Mundijong Sales Yard

Building and incidental structures inspection report

June 2020

Cantilevered connection to building E

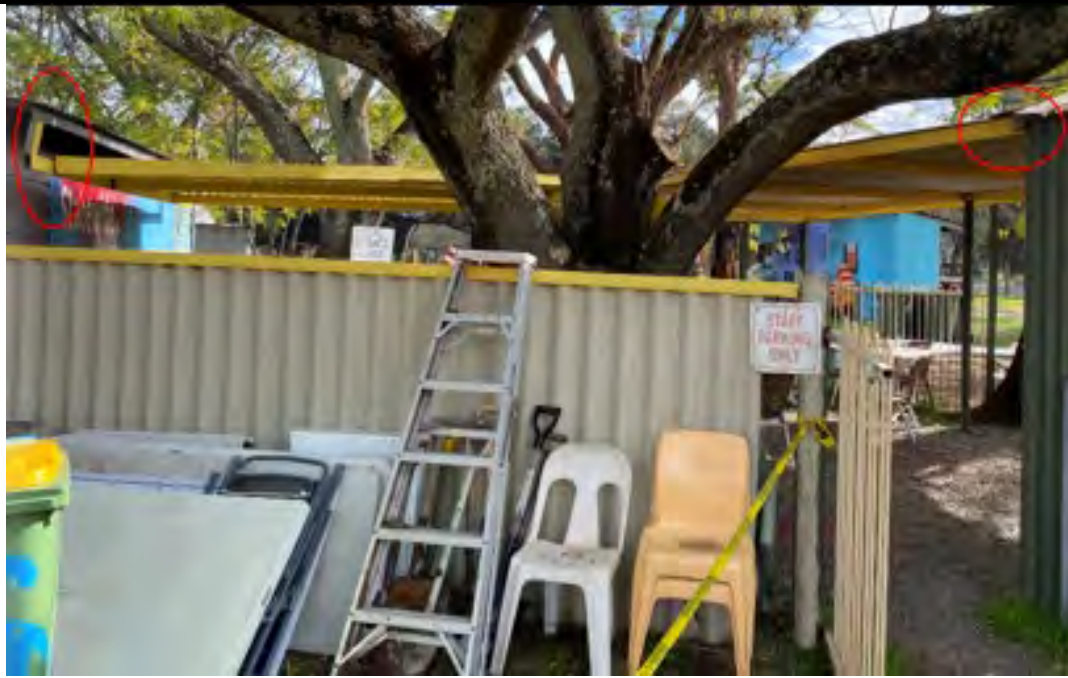
Description	A flat roof steel frame patio with sheet metal roof cladding and approx. 75mm x 38mm rectangular steel hollow patio tube posts. The flat roof patio is attached to the kitchen with server building (Structure C) and also attached to the rear of a stock yard Shed (structure E) by a cantilevered attachment
Condition	The structure appears to be in good condition although the steel tubing used as upright columns is generally used as roof beams or rafters with larger square hollow sections used as posts. Structural beams of structure E where patio is attached by Cantilevered attachment is exposed to weather and continue to deteriorate.

Build date	unclear
Approval	None on record
Recommendation	Engage a suitably qualified structural engineer to inspect and certify the patio structure. Modifications may be required in order to certify the structural adequacy of the patio structure. Install roof guttering to capture storm water run-off and direct it away from the footings of any structures such as to a soak well.
